CHELAN COUNTY NATURAL RESOURCE DEPARTMENT
COIC IMPROVEMENT PROJECT – INTAKE AND PUMPING FACILITIES

ADDENDUM NO. 3

C-01

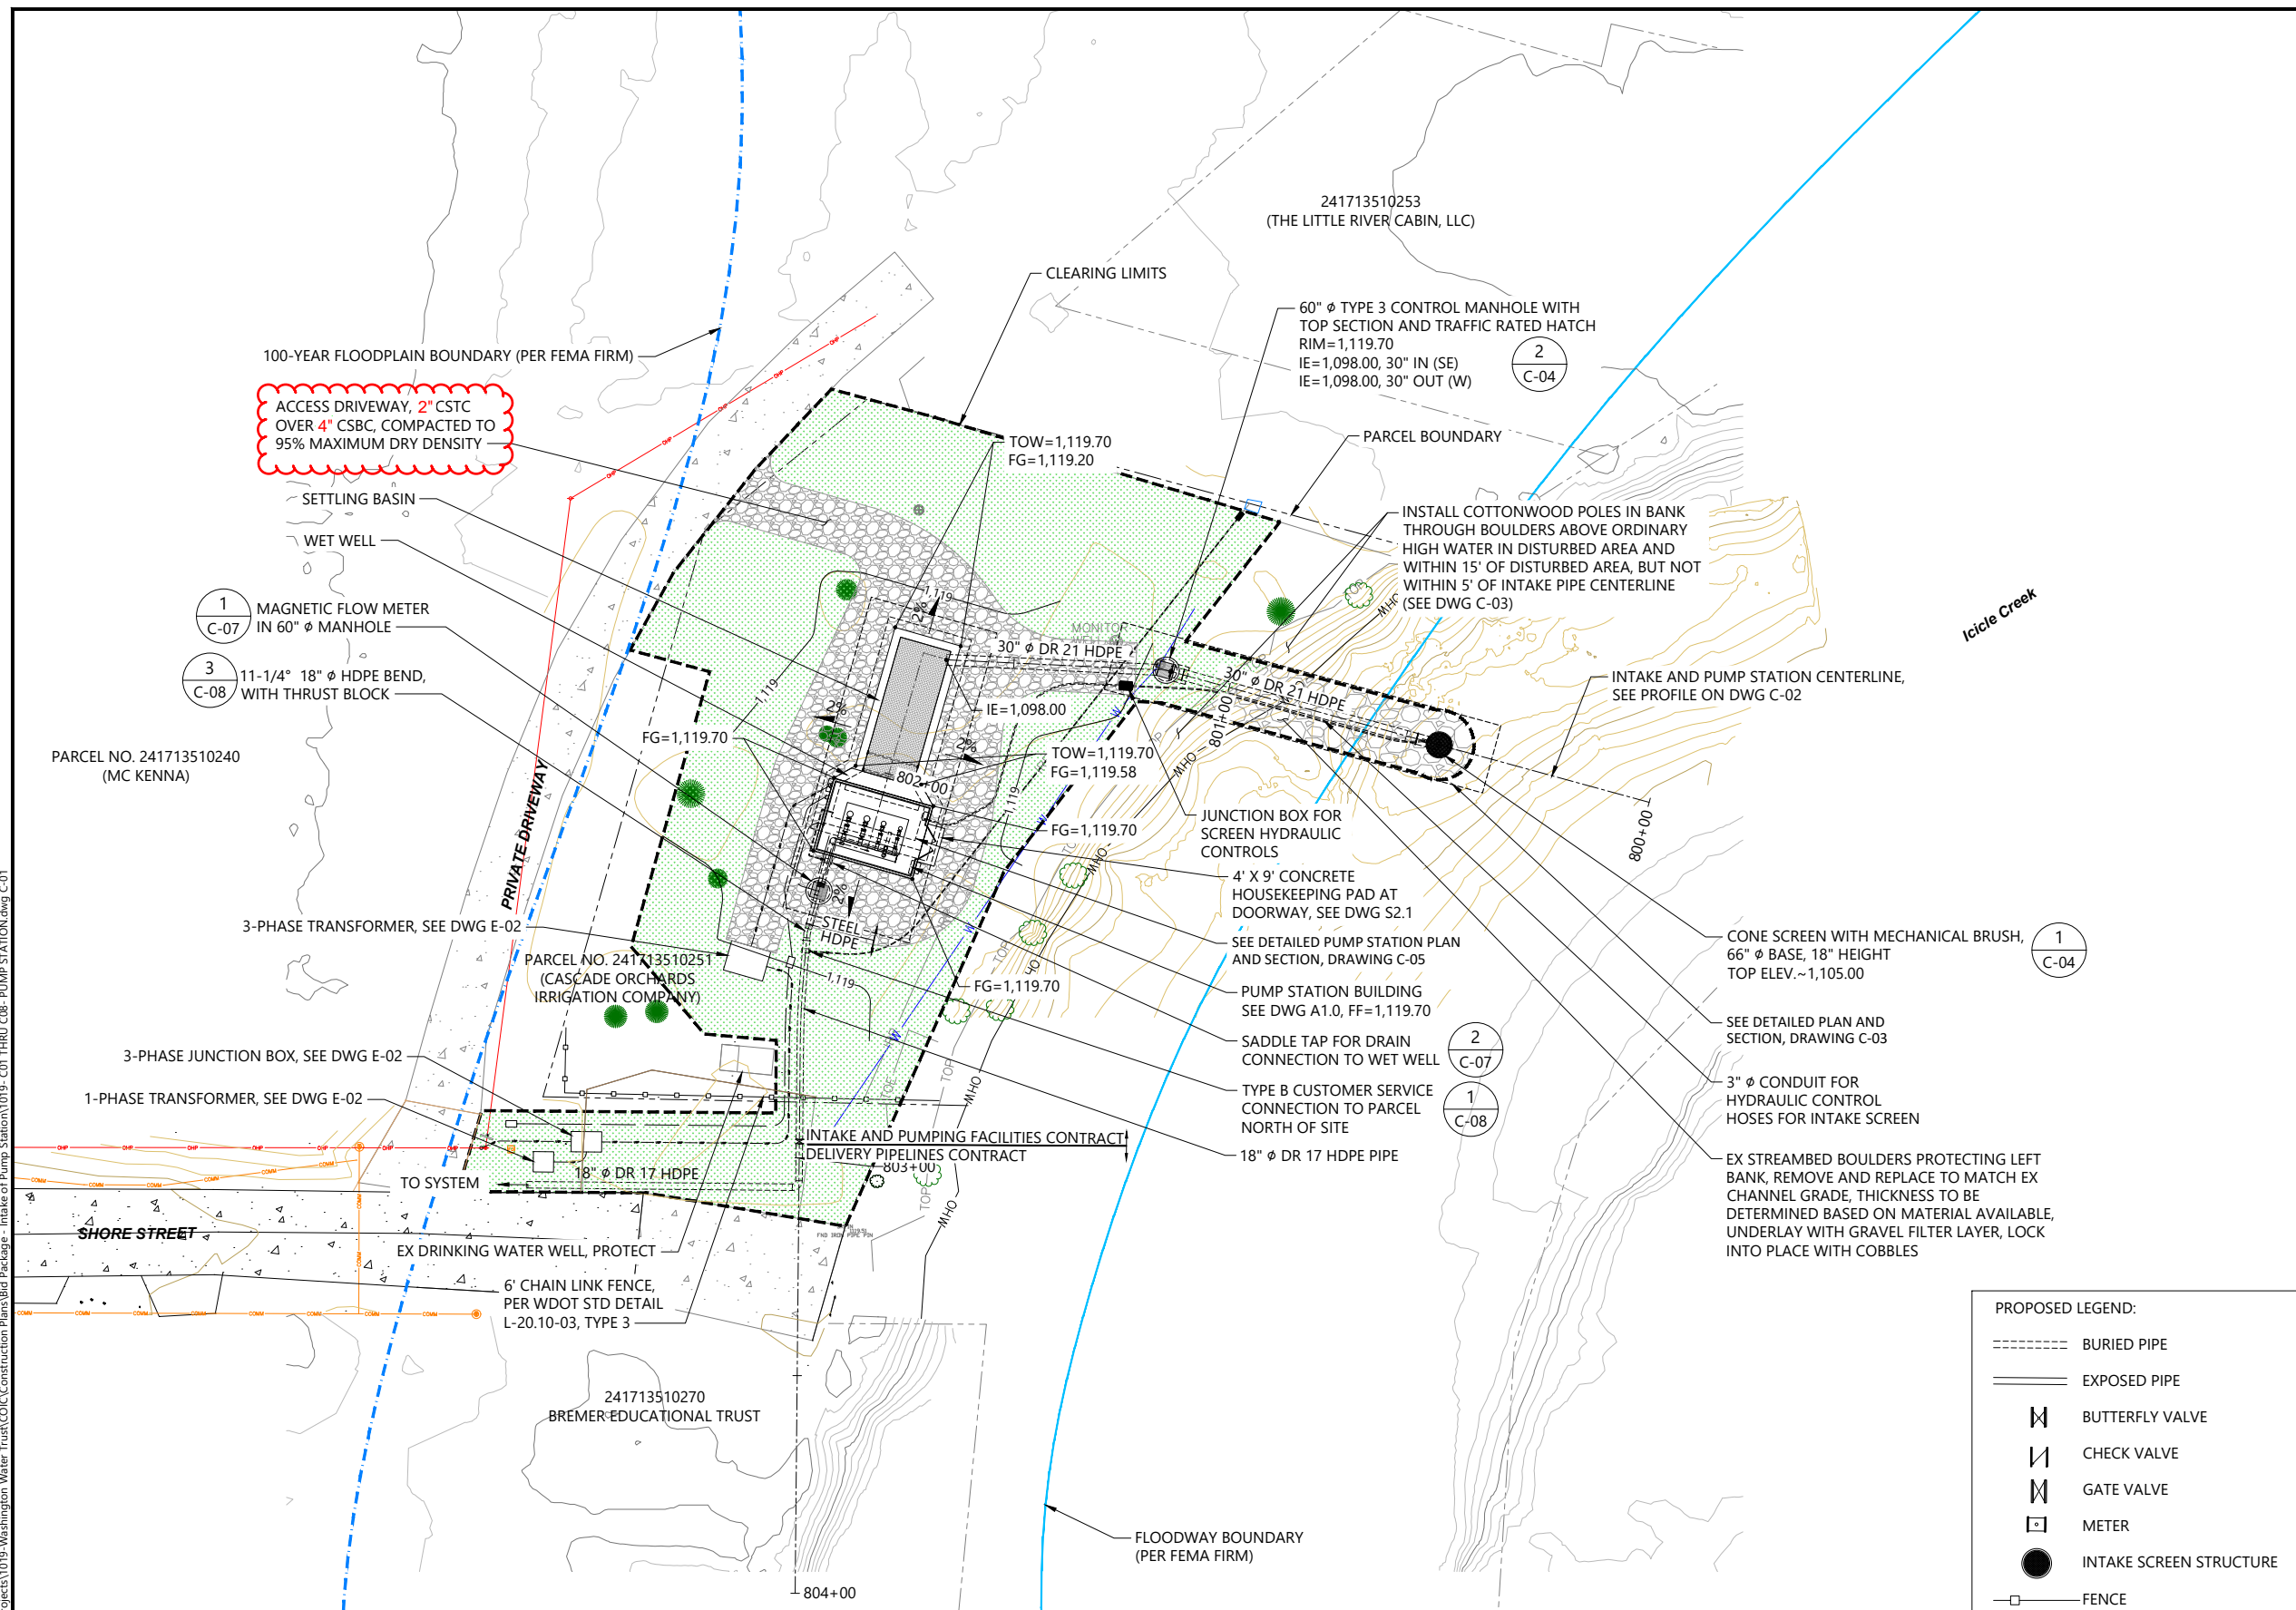
The call-out referring to the composition of the crushed rock surfacing placed for access around the pump station and settling basin is revised to require 2 inches of crushed surfacing top course (CSTC) over 4 inches of crushed surfacing base course (CSBC), as shown on the attached red-line of Drawing C-01. This correction was made to represent the design intent and to be consistent with the quantities of CSTC and CSBC shown for Bid Item 25 – Crushed Surfacing Base Course, and Bid Item 26 – Crushed Surfacing Top Course provided in the Bid Proposal form. This has been included as part of Appendix D to this Addendum.

C-03

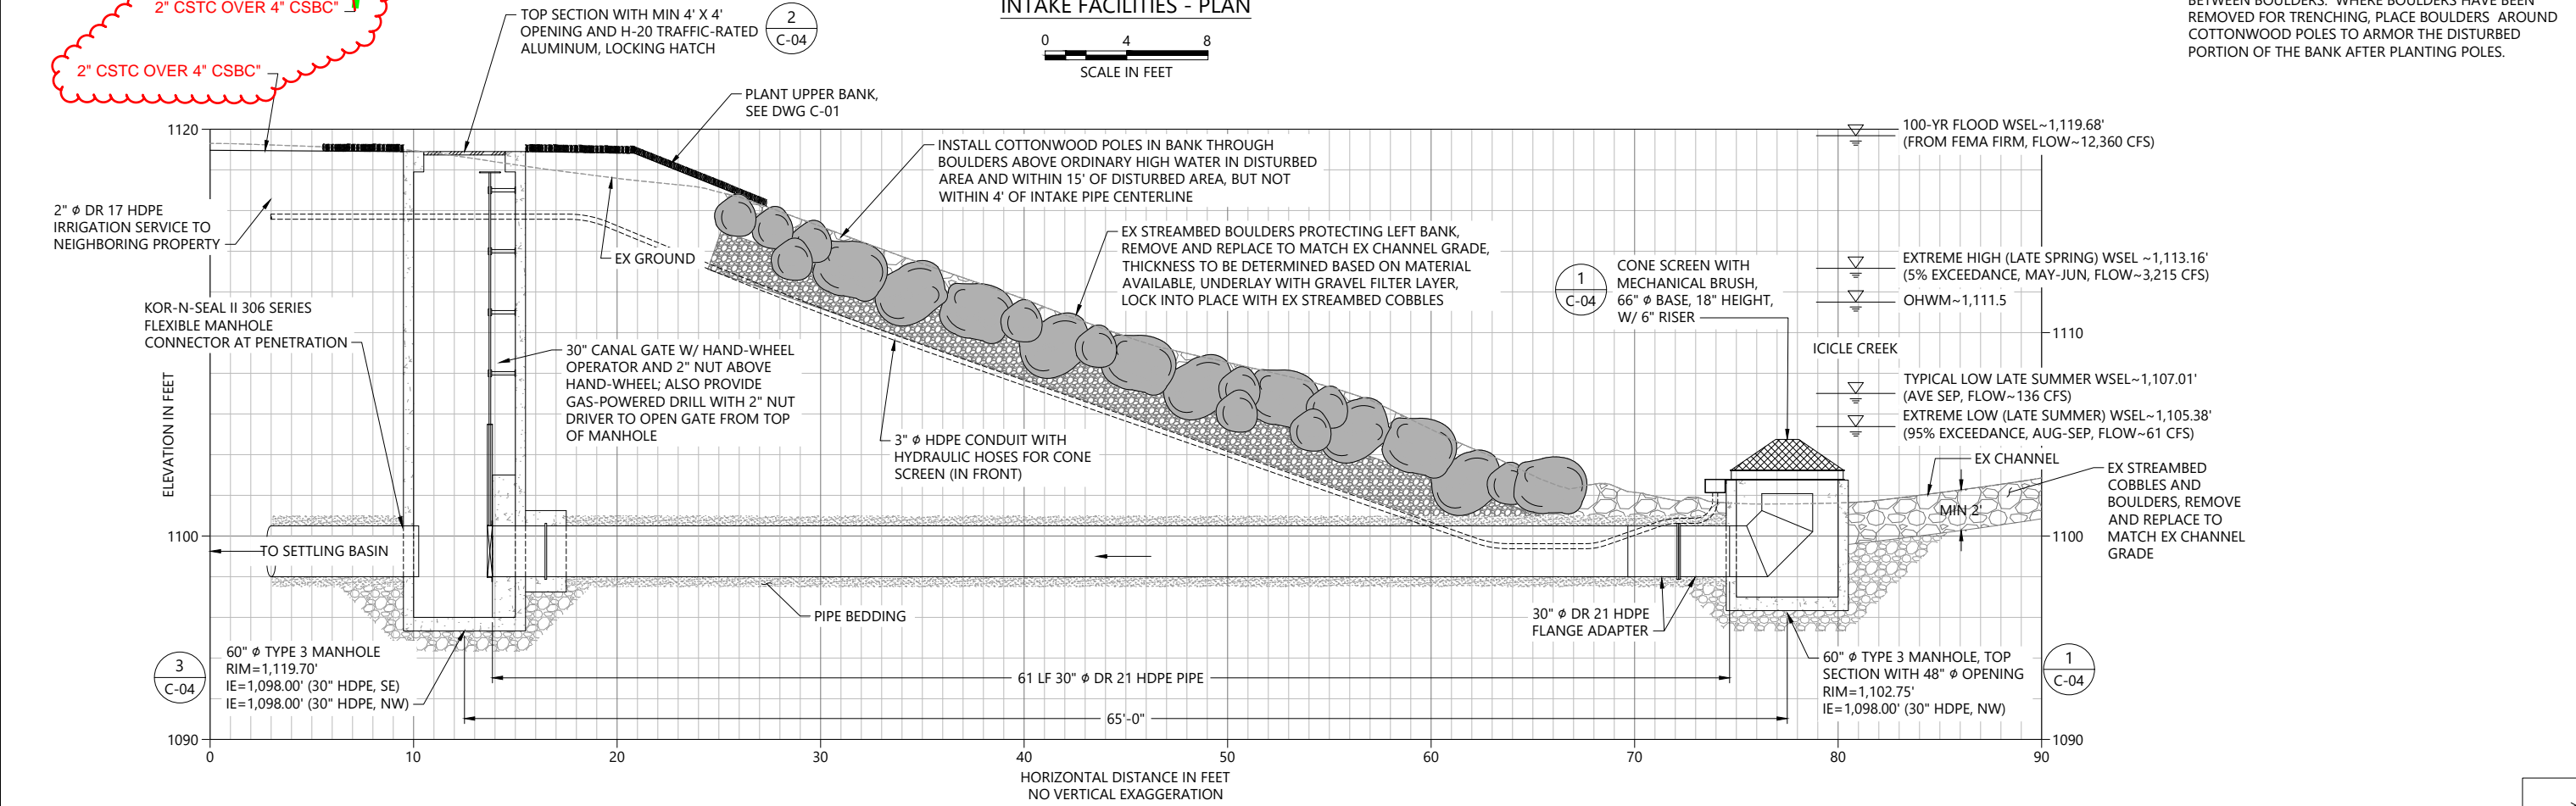
The call-out referring to the composition of the crushed rock surfacing placed for access around the pump station and settling basin is revised to require 2 inches of crushed surfacing top course (CSTC) over 4 inches of crushed surfacing base course (CSBC), as shown on the attached red-line of Drawing C-03. This correction was made to represent the design intent and to be consistent with the quantities of CSTC and CSBC shown for Bid Item 25 – Crushed Surfacing Base Course and Bid Item 26 – Crushed Surfacing Top Course provided in the Bid Proposal form. This has been included as part of Appendix D to this Addendum.
